White Oak Bayou Community Update

I-10 from Heights Blvd. to I-45
Harris County, Texas
CSJ 0271-07-326

You Spoke and TxDOT Listened

You Spoke and TxDOT Listened: Reduced Mainlane Height

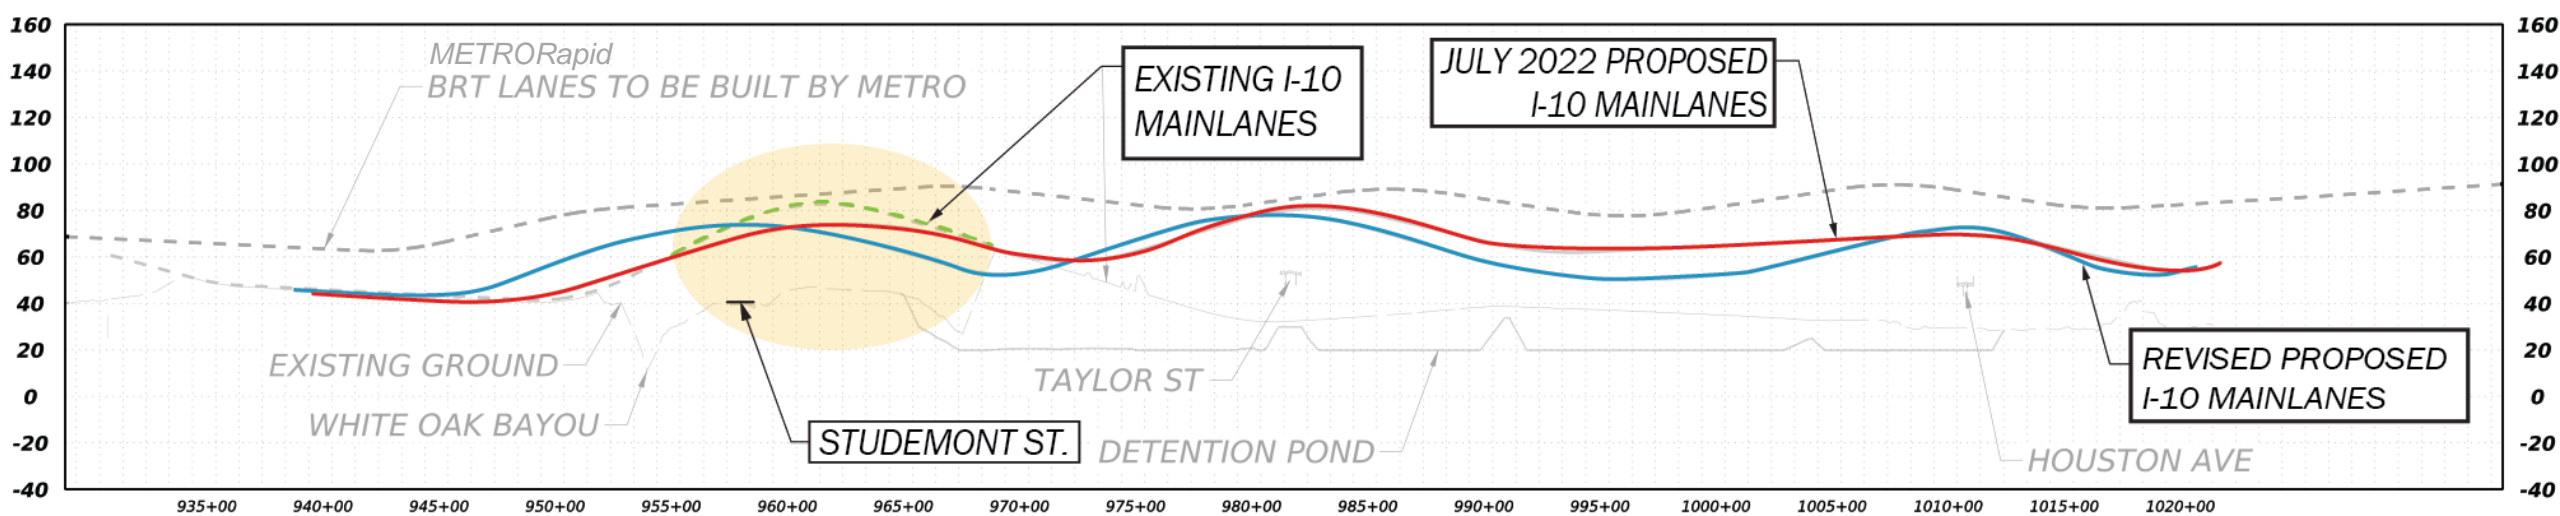
- I-10 mainlanes just east of Studemont Street would be approximately 10 feet lower than existing, keeping mainlanes at or below existing HOV

You Spoke and TxDOT Listened: Reduced HOV Height

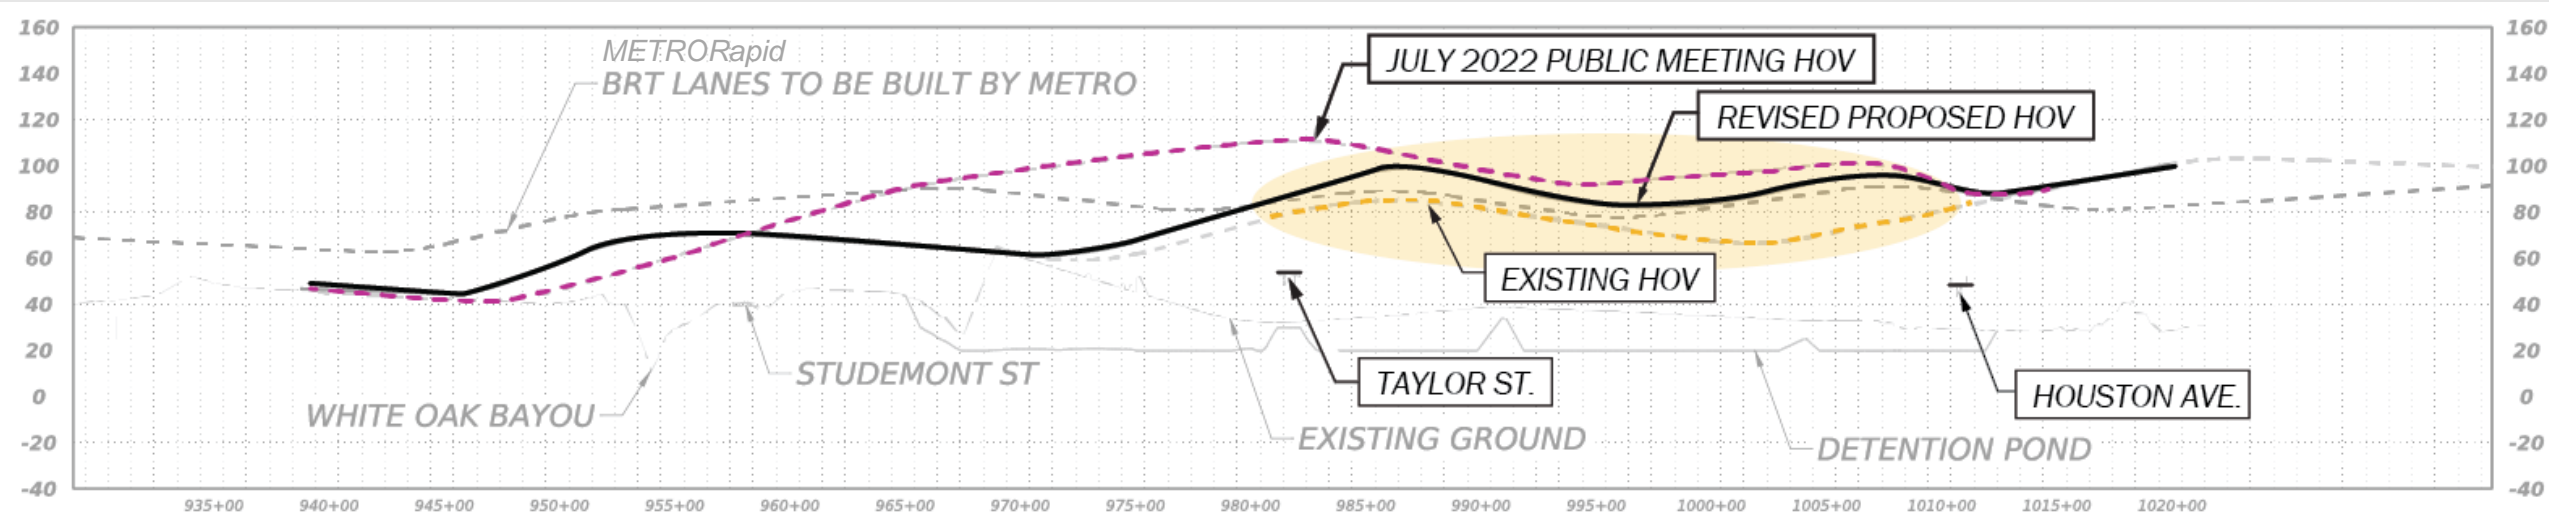
- Reconstructed HOV structure would be only approximately 10 feet higher than existing HOV at Taylor Street and Houston Avenue

View from Stude Park looking Southeast

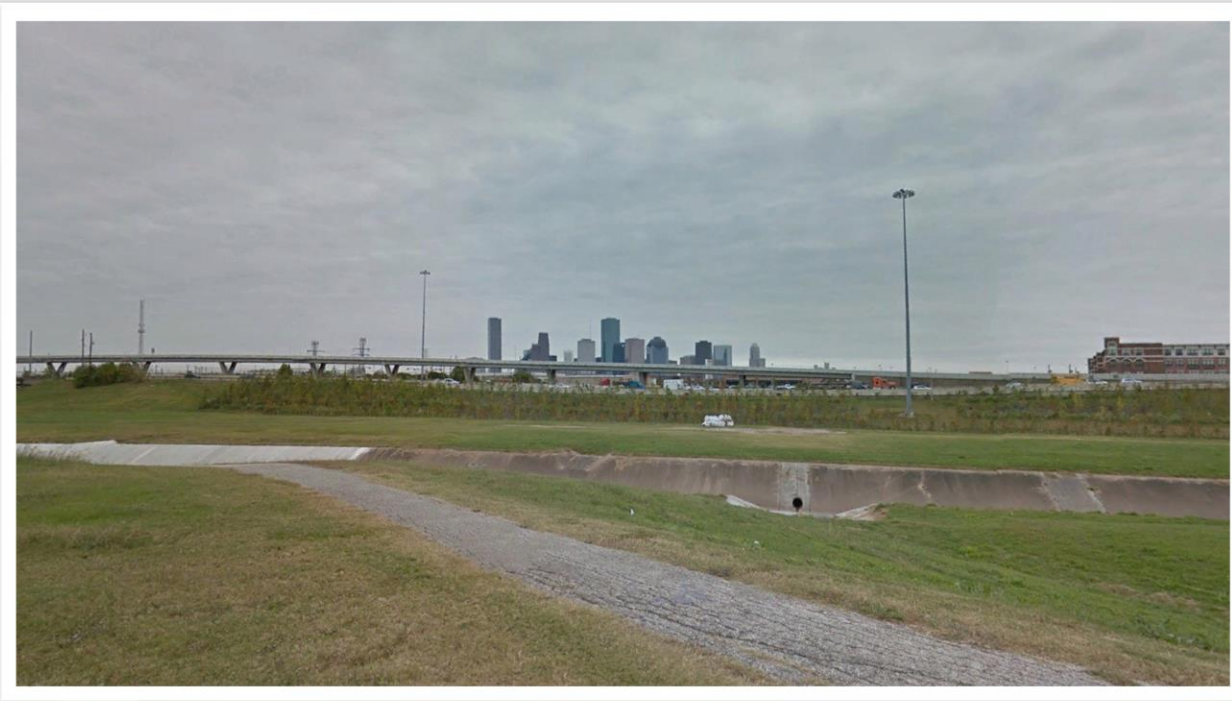
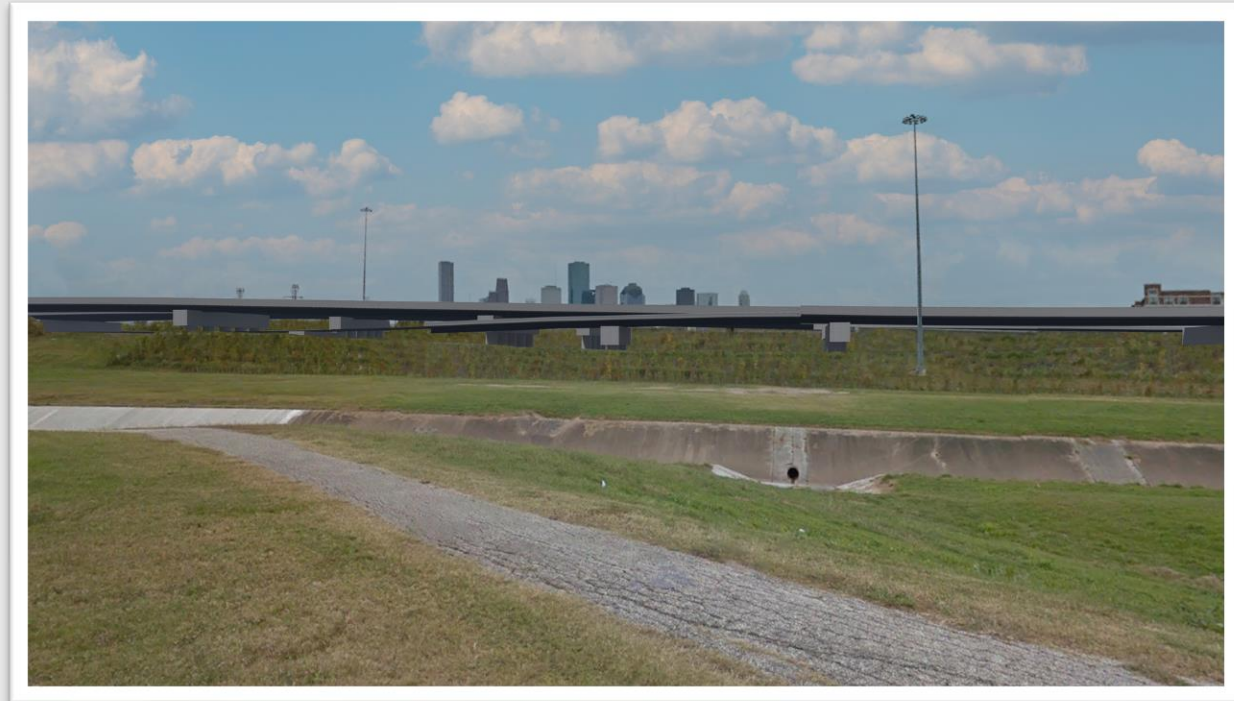
You Spoke and TxDOT Listened: Reduced HOV Height

Proposed Design Update Item No. 2

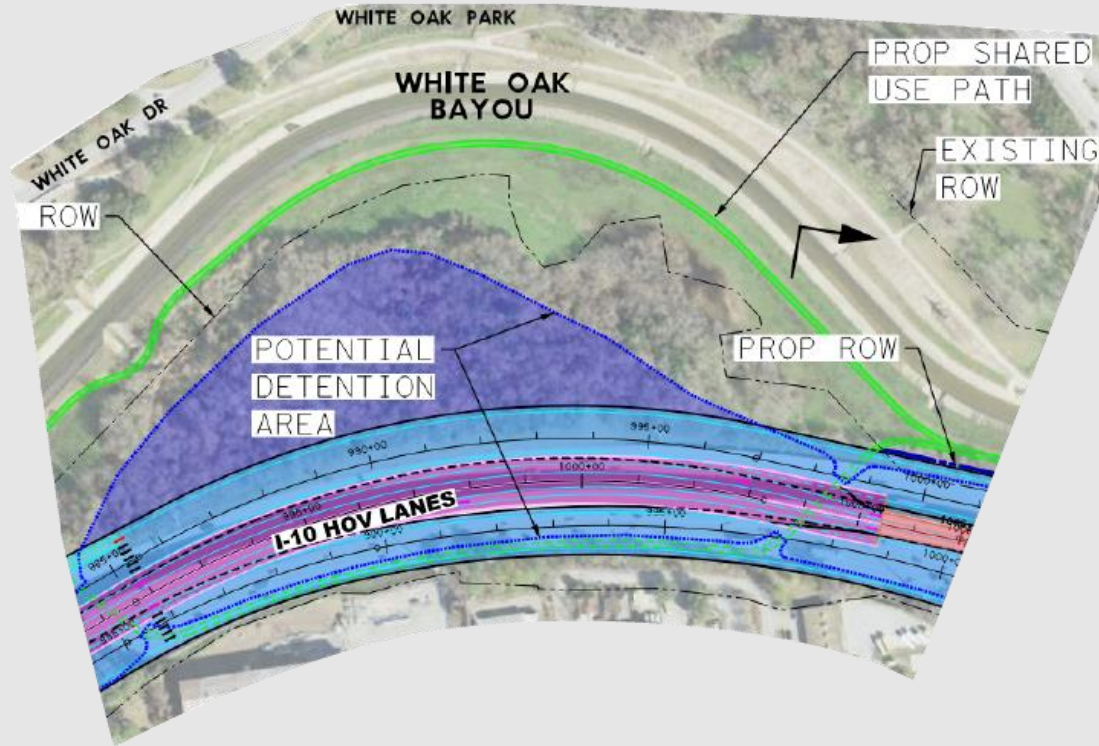
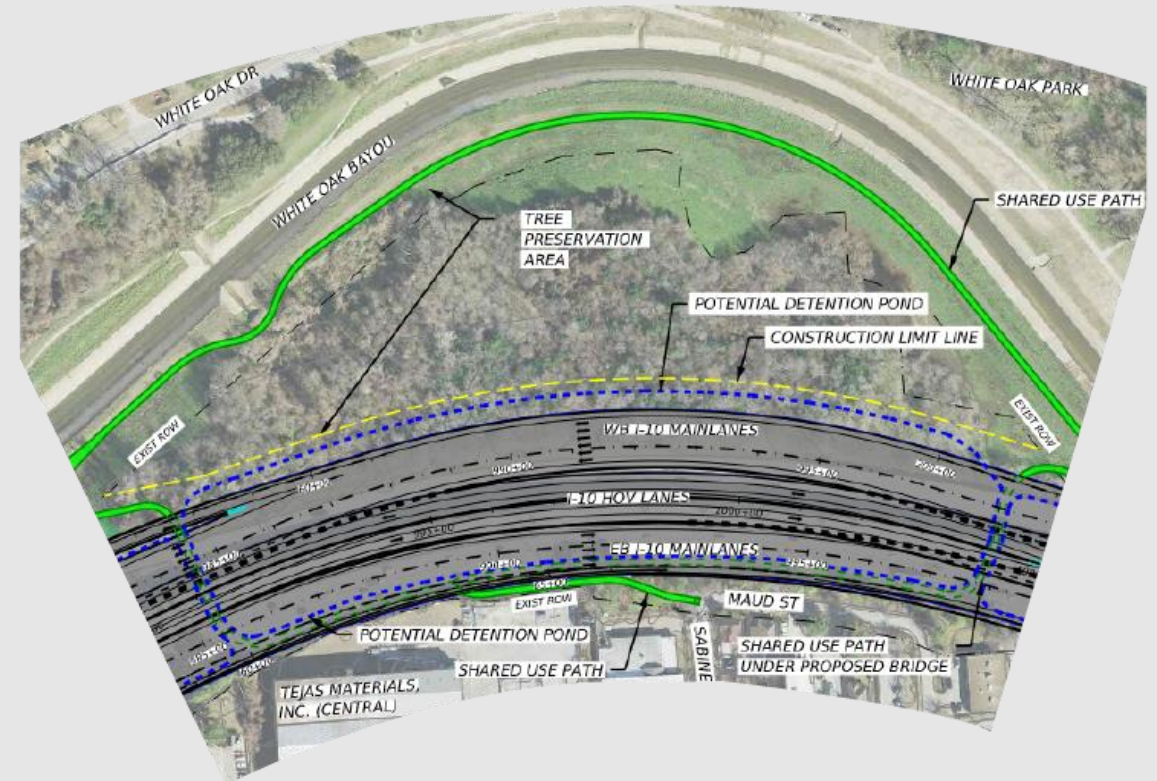
- Detention area redesigned, existing forested area west of Houston Avenue and north of I-10 would be preserved

Proposed Design Update Item No. 3

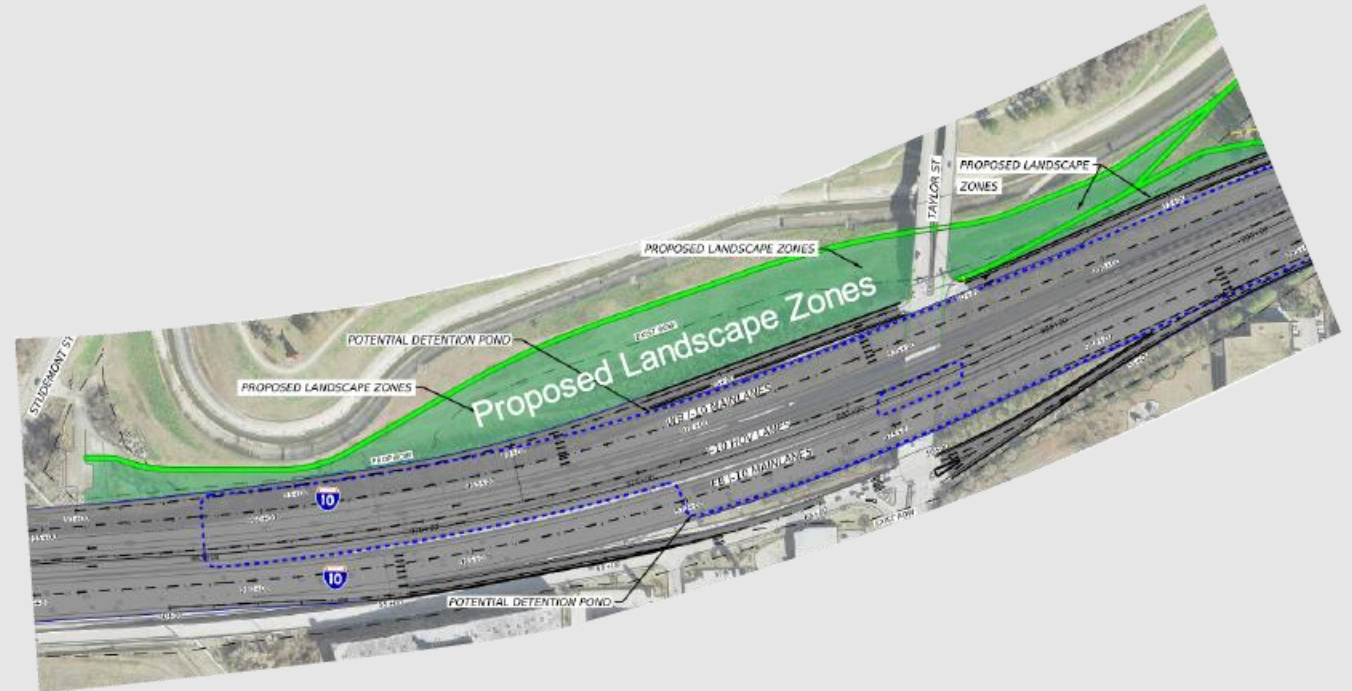
- TxDOT is coordinating with Harris County Flood Control District (HCFCD) to place vegetative and tree plantings along White Oak Bayou within project limits

Proposed Design Update Item No. 4

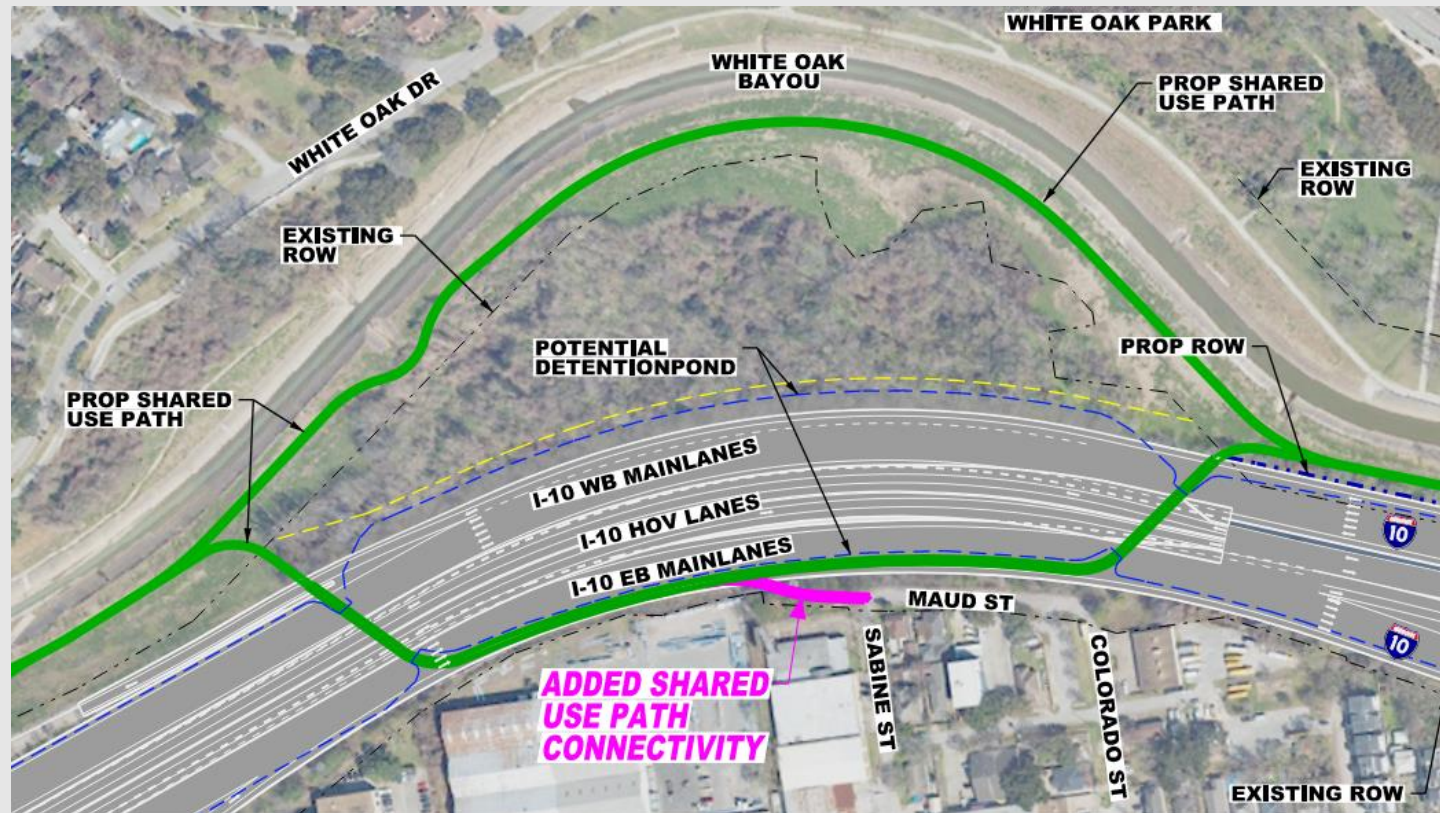
- Evaluating options to enhance connectivity from proposed shared use path (SUP), including connection south of I-10 at Sabine Street/Maud Street

Proposed Design Update Item No. 5

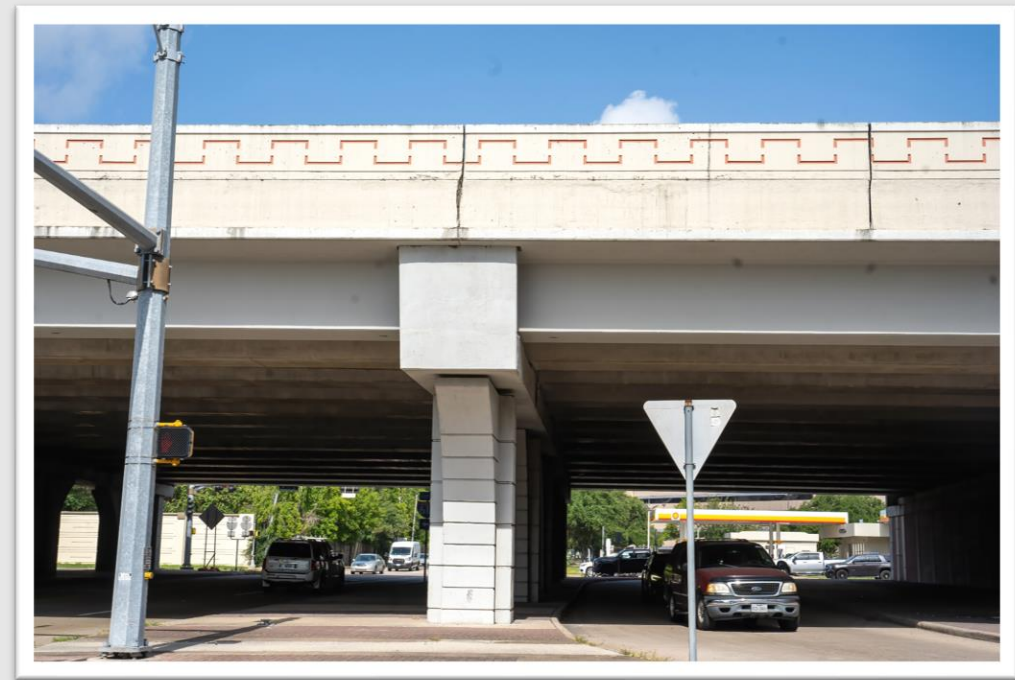
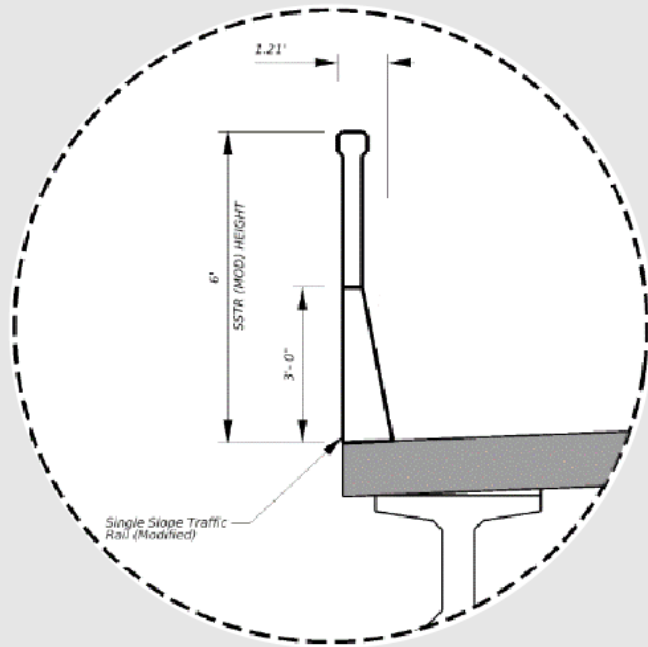
- Six-foot minimum height rails on outside of elevated mainlanes and HOV bridges, similar to I-610 West Loop rail heights in Bellaire
- Aesthetic treatments and colors will differ for the I-10 project from what is shown

Proposed Design Update Item No. 6

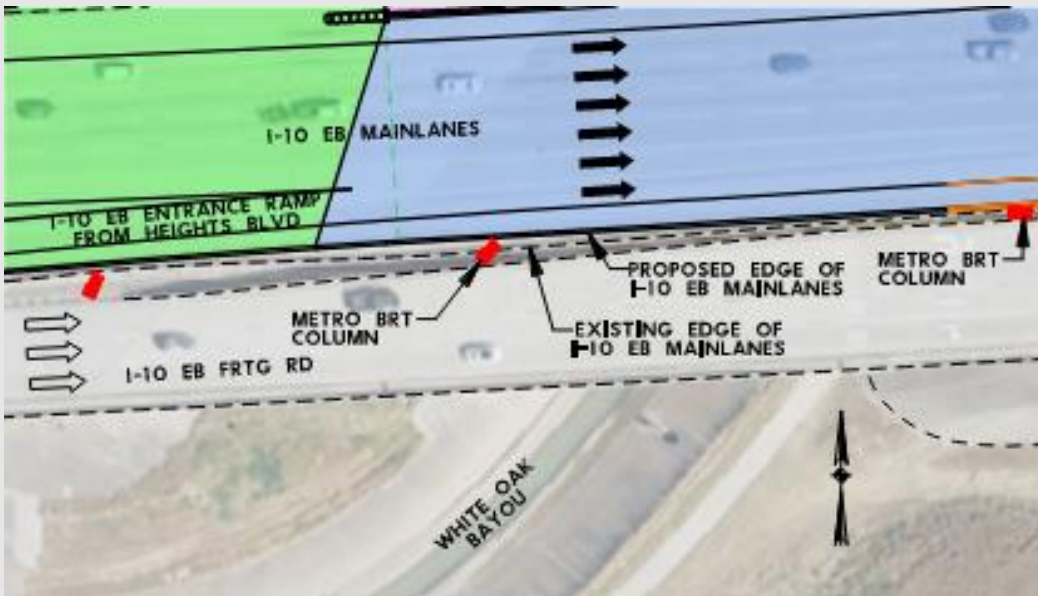
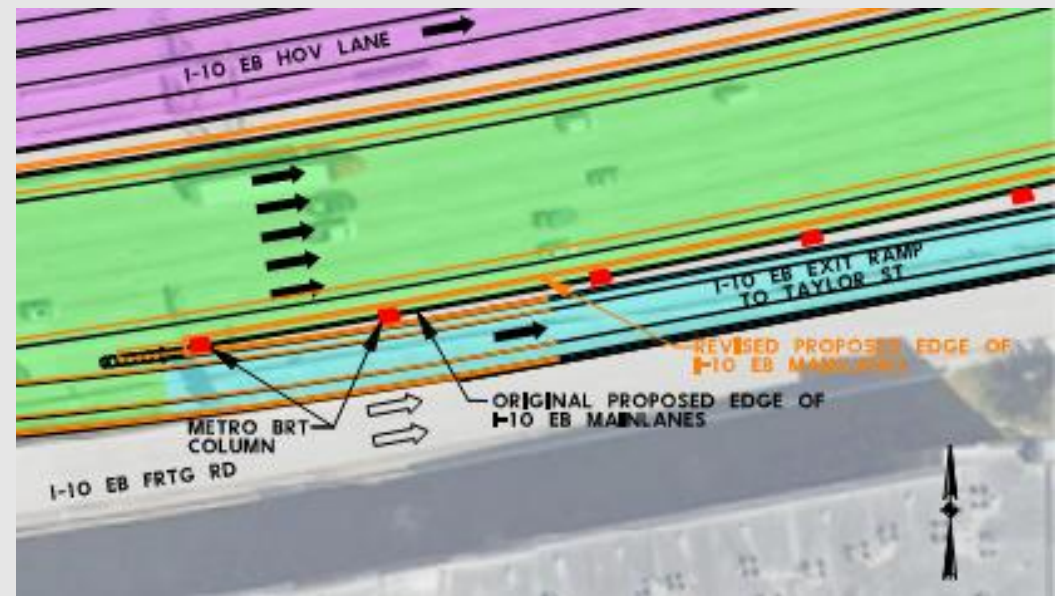
- TxDOT is working closely with METRO to implement METRO's proposed Inner Katy BRT which cannot be built without this project moving the I-10 eastbound mainlanes to provide space for METRO to place columns and foundations for the BRT structure.

Relocation of existing I-10 edge of pavement west of Studemont Street

Relocation of proposed I-10 edge of pavement west of Taylor Street

- Not to exceed 1.201 acres of additional right-of-way over the existing channel which will still be available for channel conveyance
- 18 acres of concrete would be removed and replaced with soil and vegetation
- No residential or commercial displacements are anticipated
